Attachment J3

Submissions

Planning Submission
For: SP 67057: 23 Billyard Avenue, Elizabeth Bay

Development Application ('DA') No. 2023/0727
'Demolition of existing buildings, tree removal, excavation and construction of two new residential flat buildings, 6 to 8 storeys in height, with 22 apartments, 4 basement levels containing 27 car spaces, rooftop terraces, swimming pools and associated landscaping works including new tree plantings. The application is Integrated Development requiring the approval of Water NSW under the Water Management Act, 2000.'

NOTE:
SHADOWS SHOWN HAVE BEEN COMPILED FROM INFORMATION FROM DETAIL & LEVEL SURVEY BY BEVERIDGE WILLIAMS SURVEYORS PROJECT NO.2202698 REV.B DATED 14.03.23 & ARCHITECTURAL PLANS & MODELS BY SMART DESIGN STUDIO

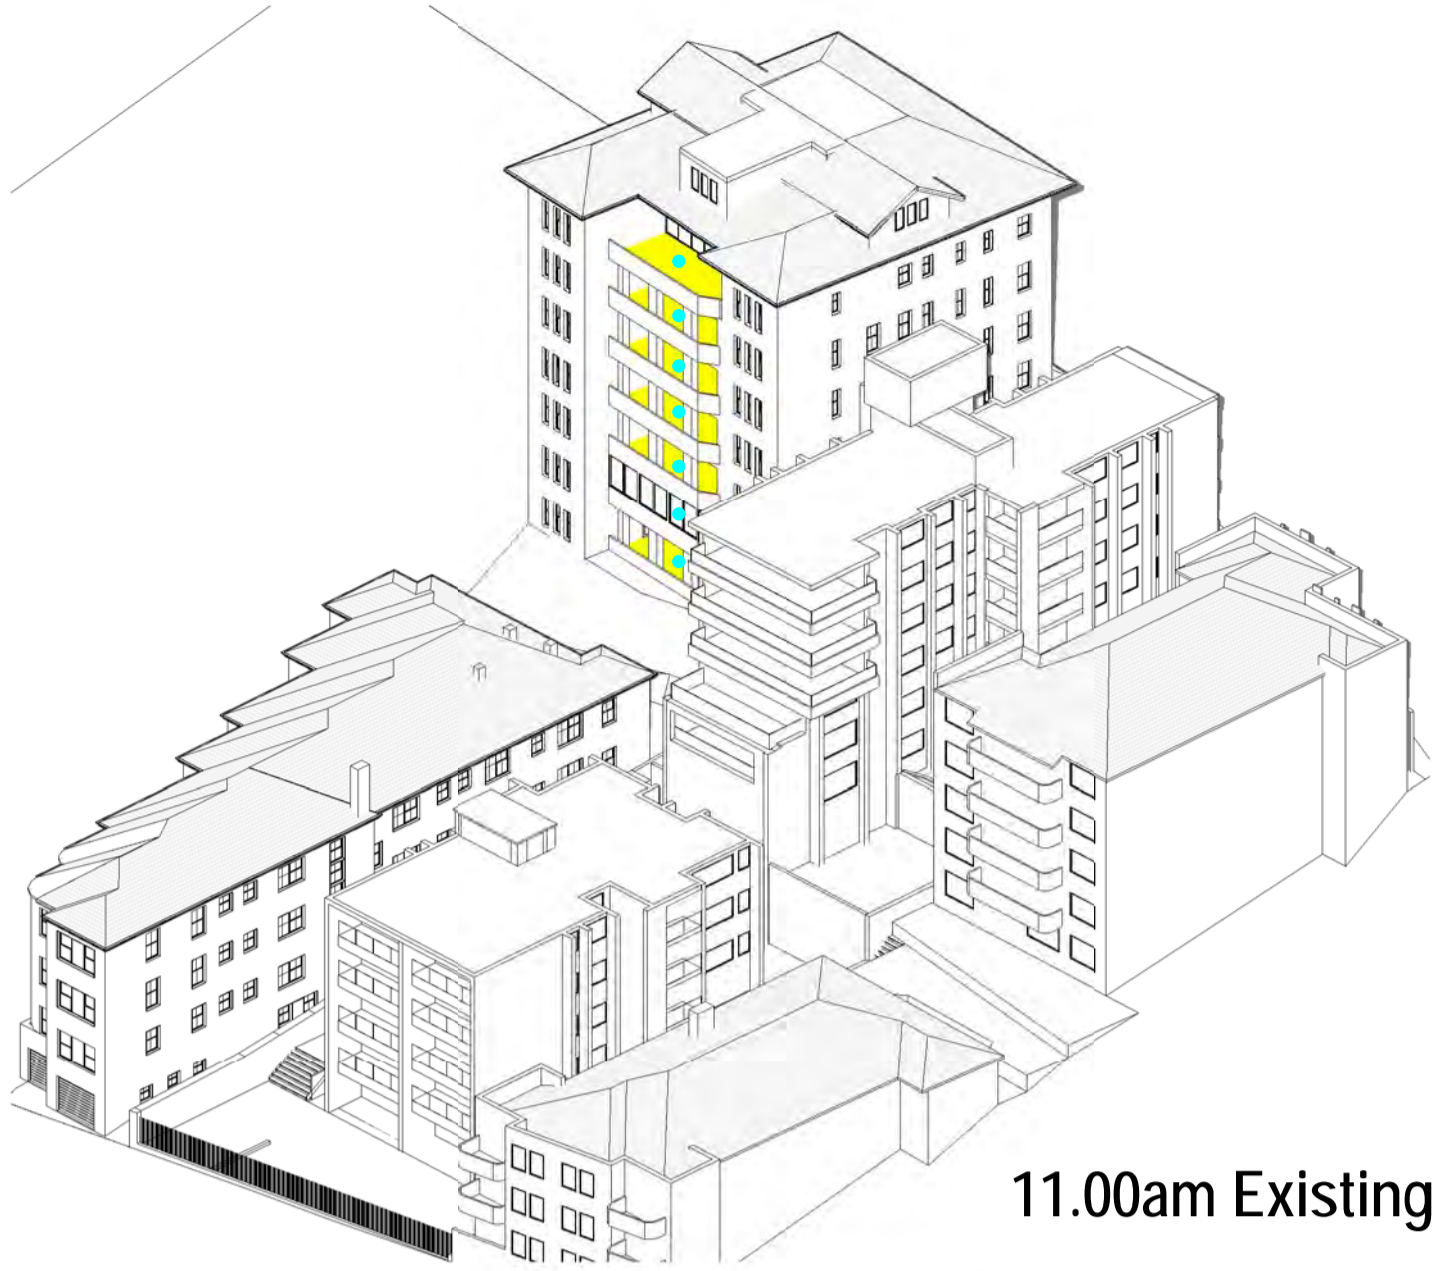
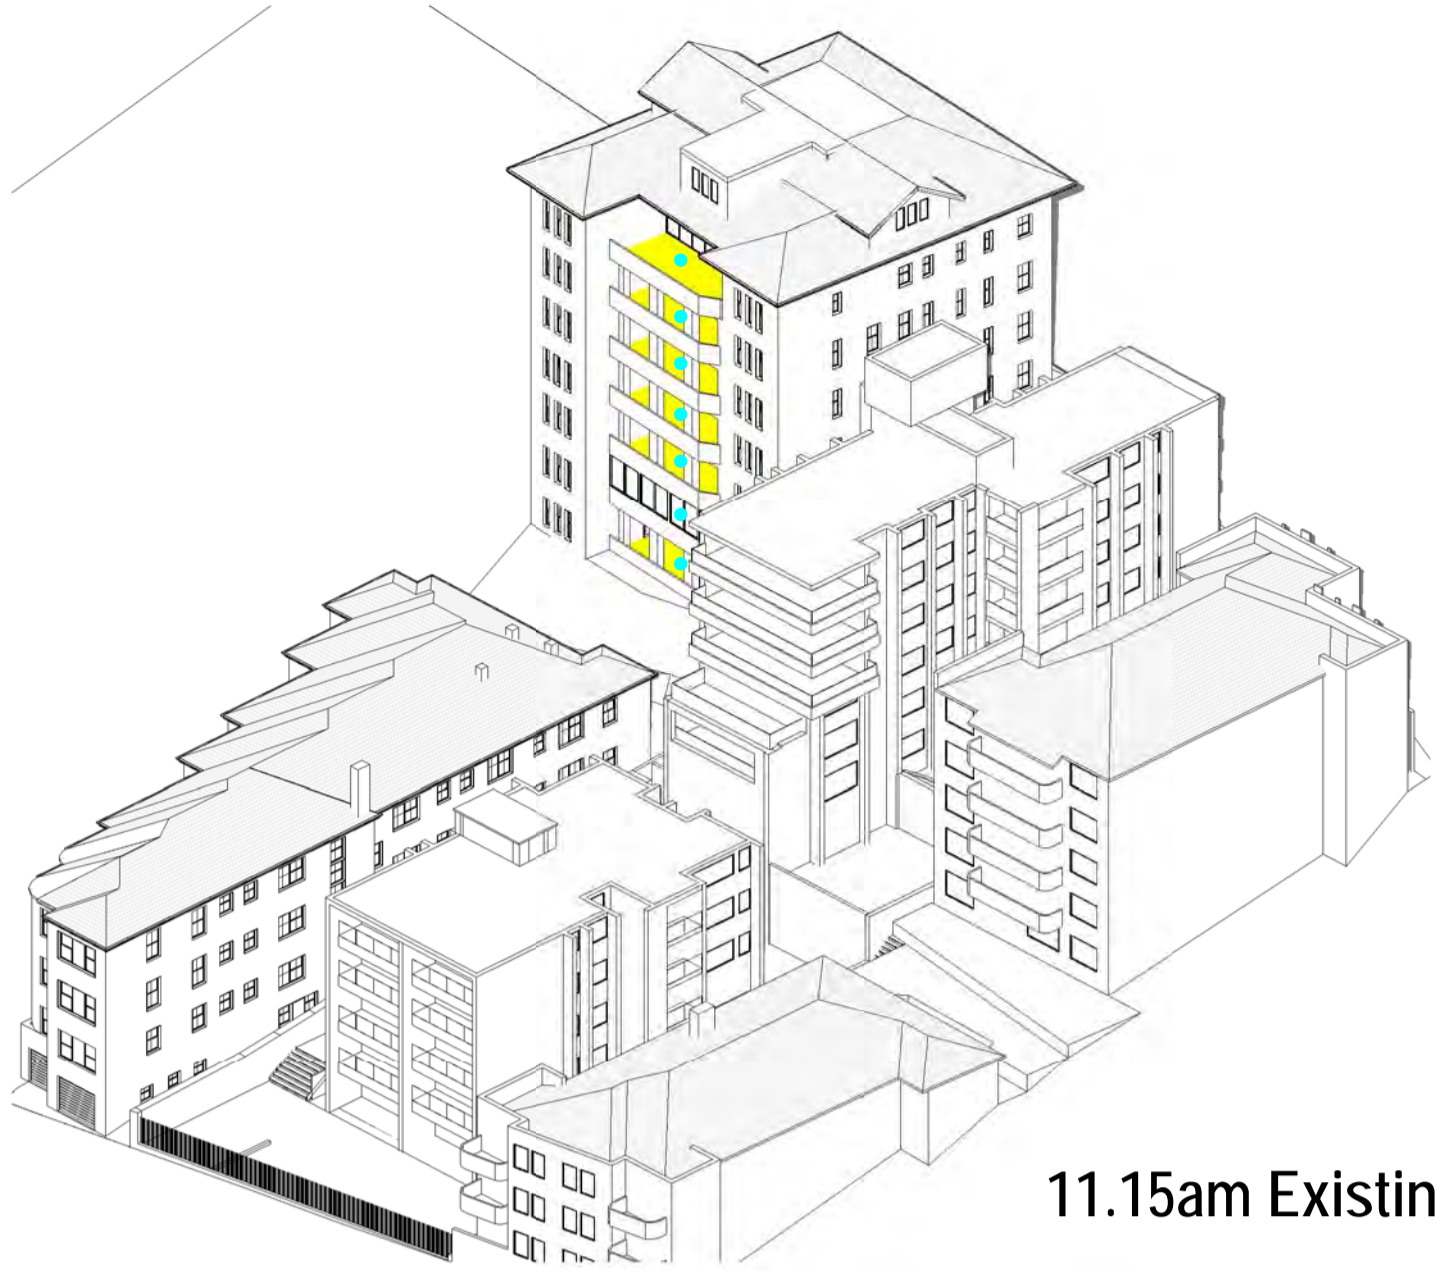
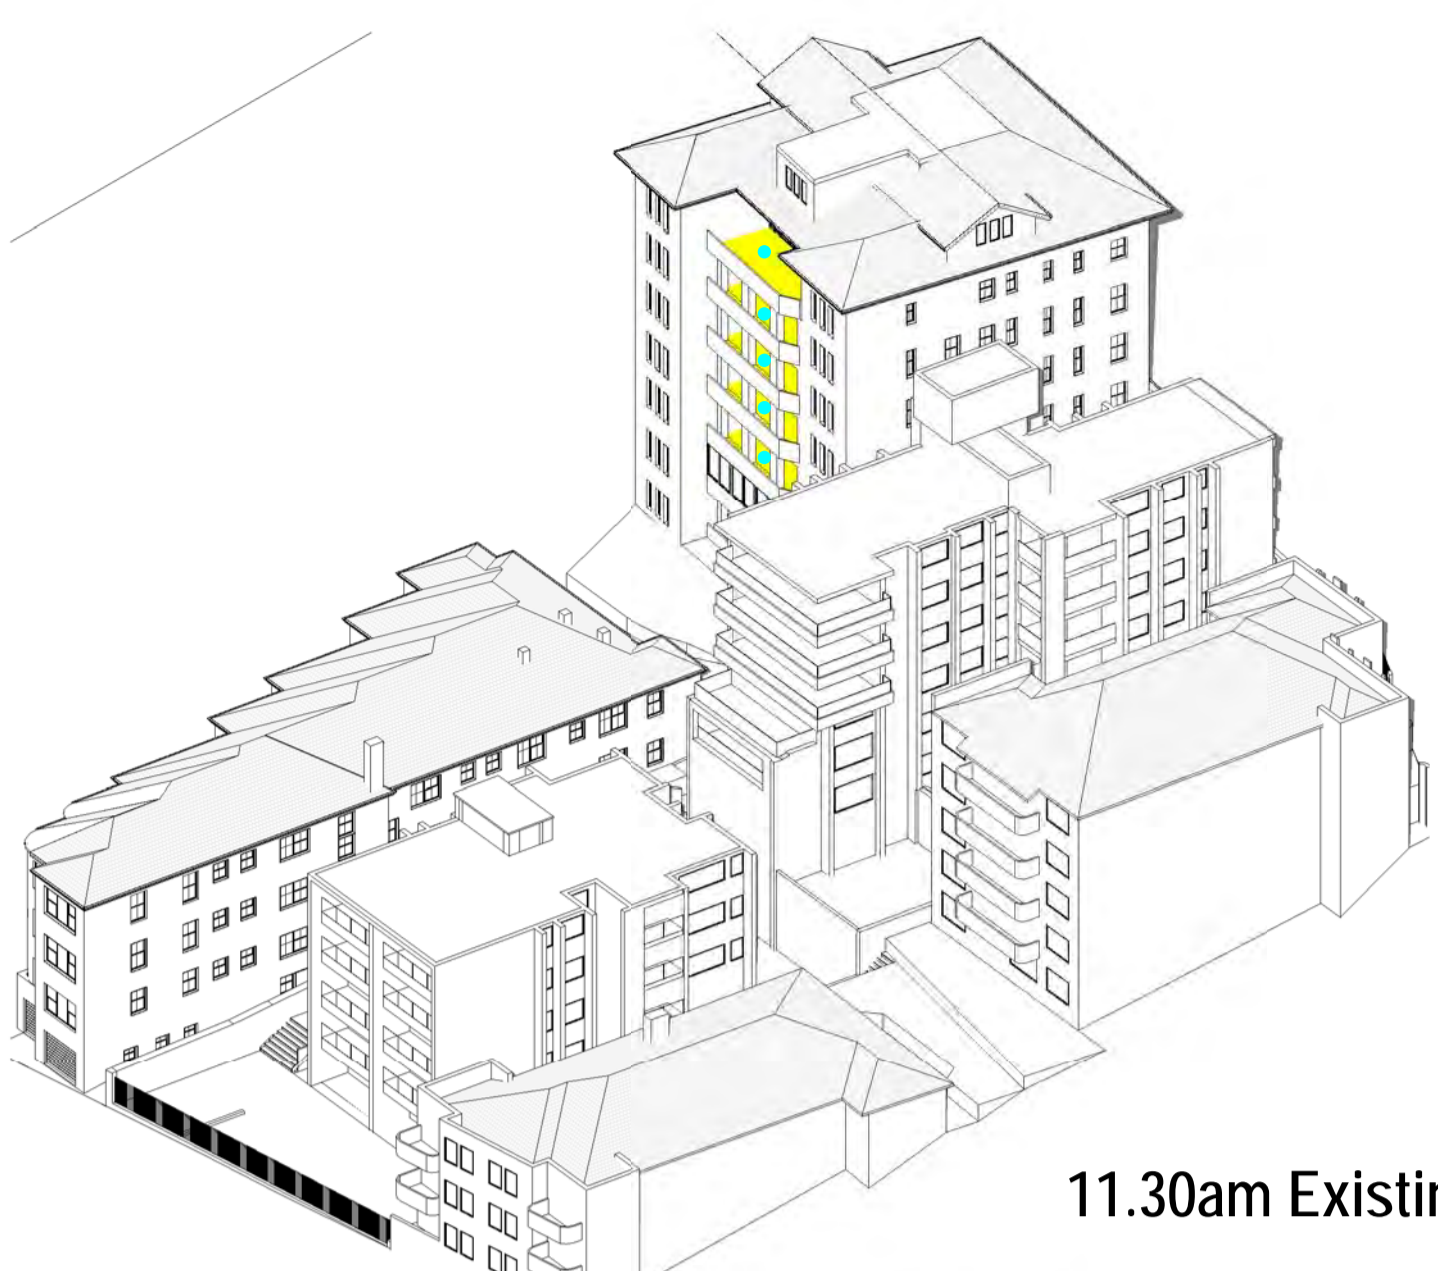
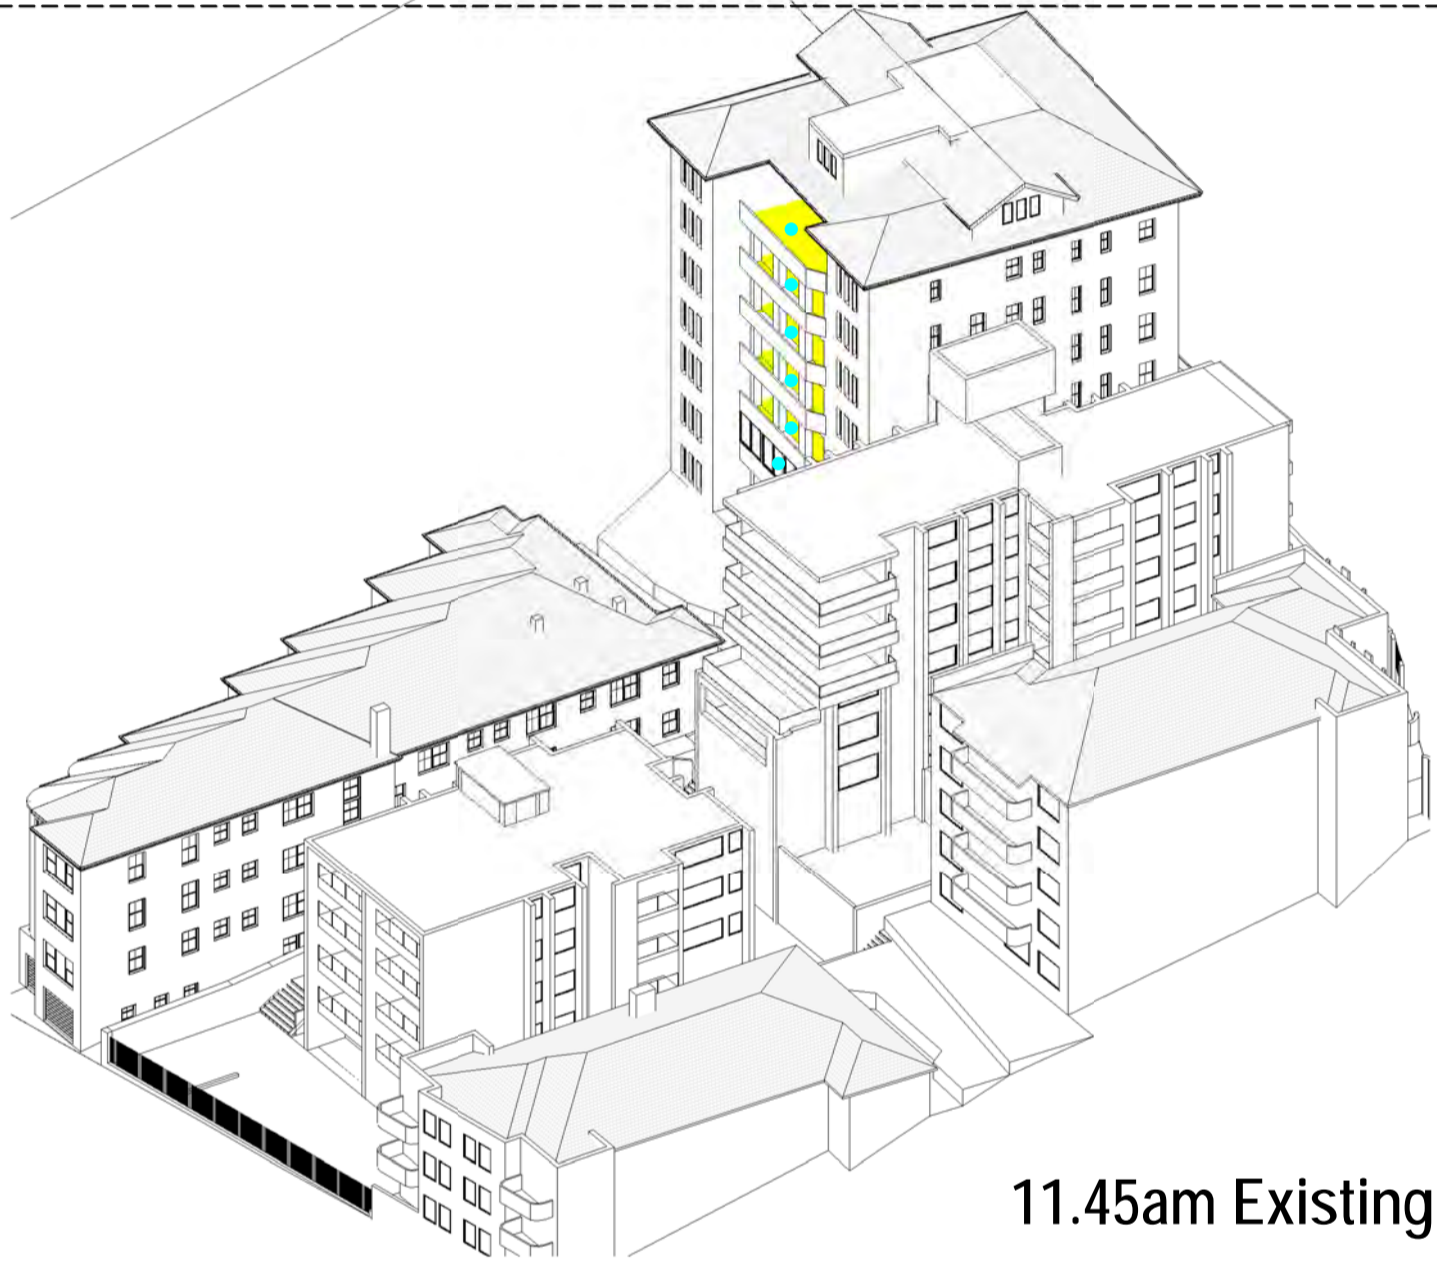
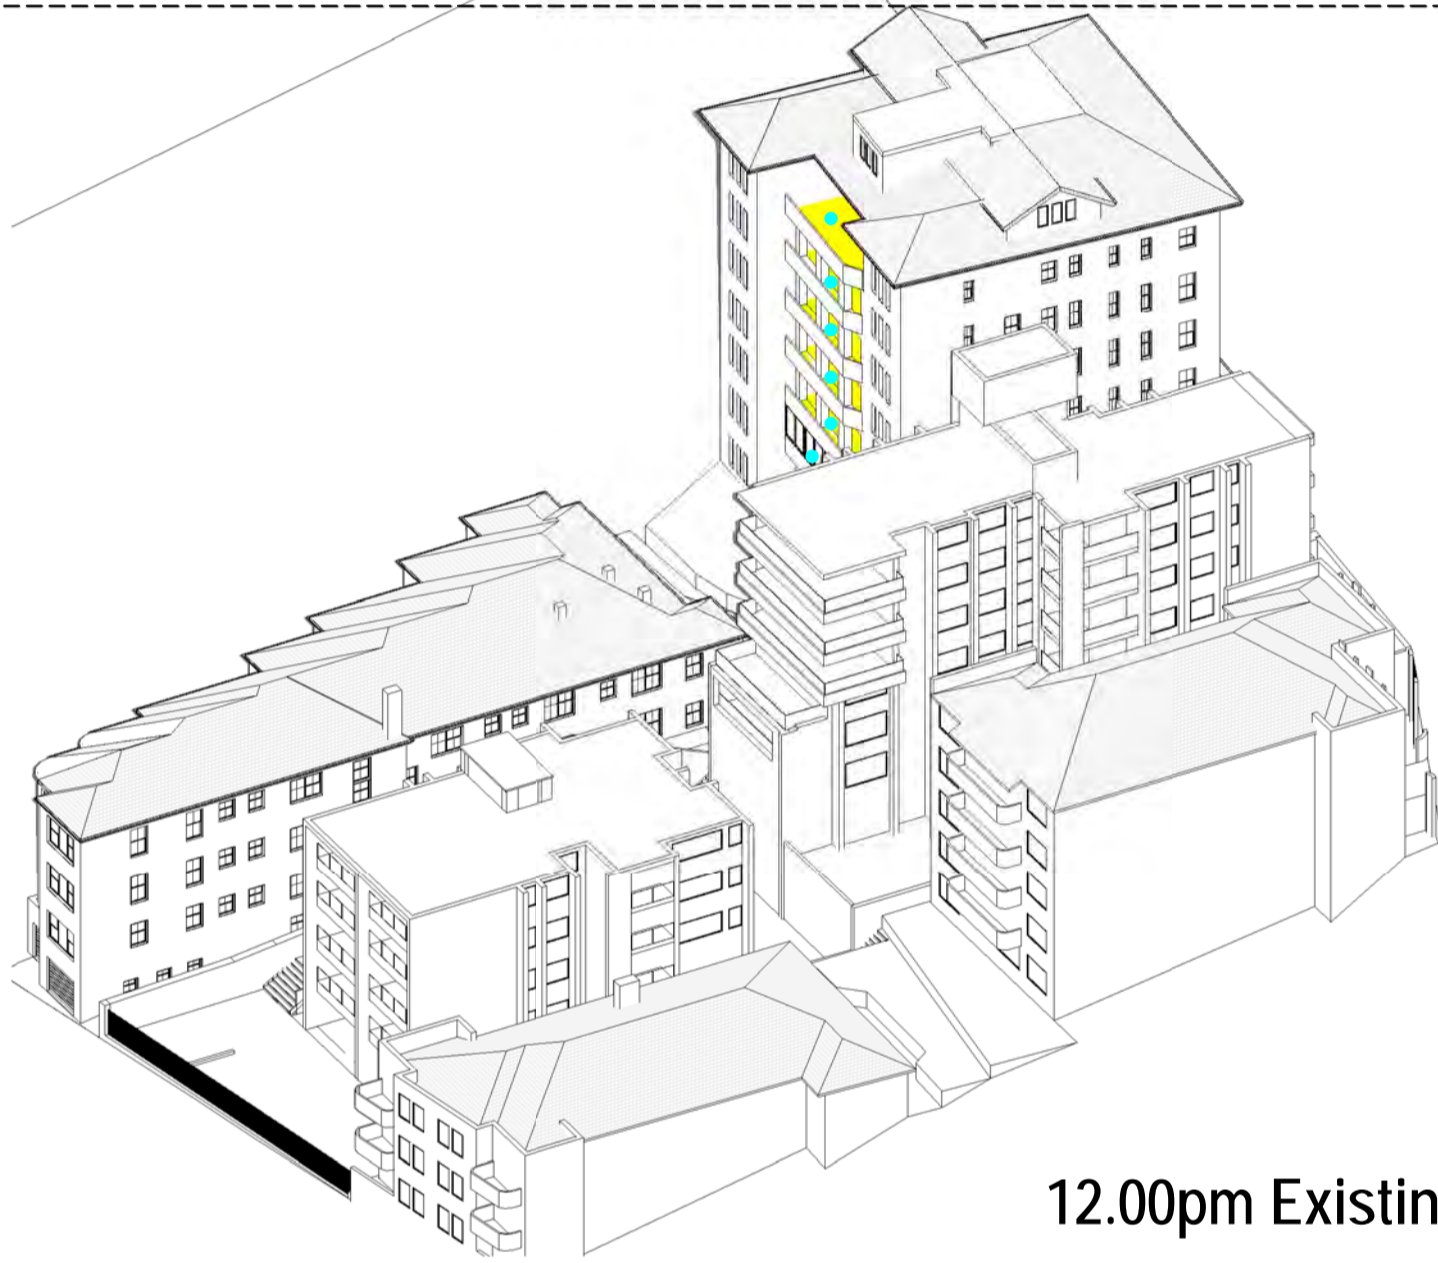
The solar diagrams show worsening of solar access to these only areas of living space (no balconies available). It is noted that staff requested 15 minute intervals and these have not been provided for 23 Billyard Avenue.

9.00AM - 3.00PM				
	EXISTING:	PROPOSED:	ACCESS LOST:	% LOST:
P.O.S.				
LG2 UNIT 1	3.25 HOURS	1.75 HOURS	- 1 HOUR	44%
LG1 UNIT 3	3.25 HOURS	1.75 HOURS	- 1 HOUR	44%
GF UNIT 5	3.25 HOURS	1.75 HOURS	- 1 HOUR	44%
1 UNIT 7	3.25 HOURS	2.25 HOURS	- 0.75 HOUR	33%
2 UNIT 9	3.25 HOURS	3.25 HOURS	0	
3 UNIT 11	3.25 HOURS	3.25 HOURS	0	
4 UNIT 12	4 HOURS	4 HOURS	0
